KAC Fashion Wear Ltd (Extension 2)

Structural Inspection Report

Office Building: 3 storey (G+2) building.

Column layout

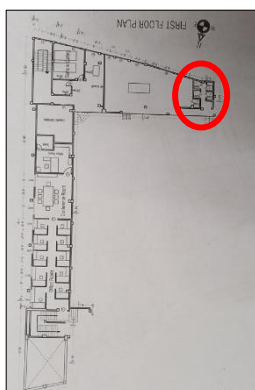
Observation-1: High stress in column & foundation.

Description: Cursory calculation indicates that the stress in column & foundation exceeds normal design limit considering 2 kPa floor live load, overhead water tank loads based on minimum concrete strength (14.1 MPa) and ultimate soil bearing capacity (1.5 tsf) from test report. The building engineer is required to check the design, loads and stress of columns & foundations of the building based on in-situ material strength & actual soil bearing capacity and suggest necessary remedial actions accordingly. Also, suggest immediate action if required by further testing & calculation.

Item	Observation	Action Plan	Timeline
01	High stress in column & foundation. (Office Building)	Verify in-situ material strength by taking a minimum of 4 cores from the lower tier of existing column.	within 6 weeks
02	High stress in column & foundation. (Office Building)	Investigate the bearing capacity of soil around the close vicinity of the building foundations.	within 6 weeks
03	High stress in column & foundation. (Office Building)	Conduct Detail Engineering Assessment (DEA) to check the design, loads and stress of columns & foundations of the building based on in-situ material strength and soil bearing capacity.	within 6 weeks
04	High stress in column & foundation. (Office Building)	Produce and actively manage a floor loading plan for all floor plates based on foundation, column & floor capacity.	within 6 weeks
05	High stress in column & foundation. (Office Building)	Carry out suggested remedial works if required.	within 6 months
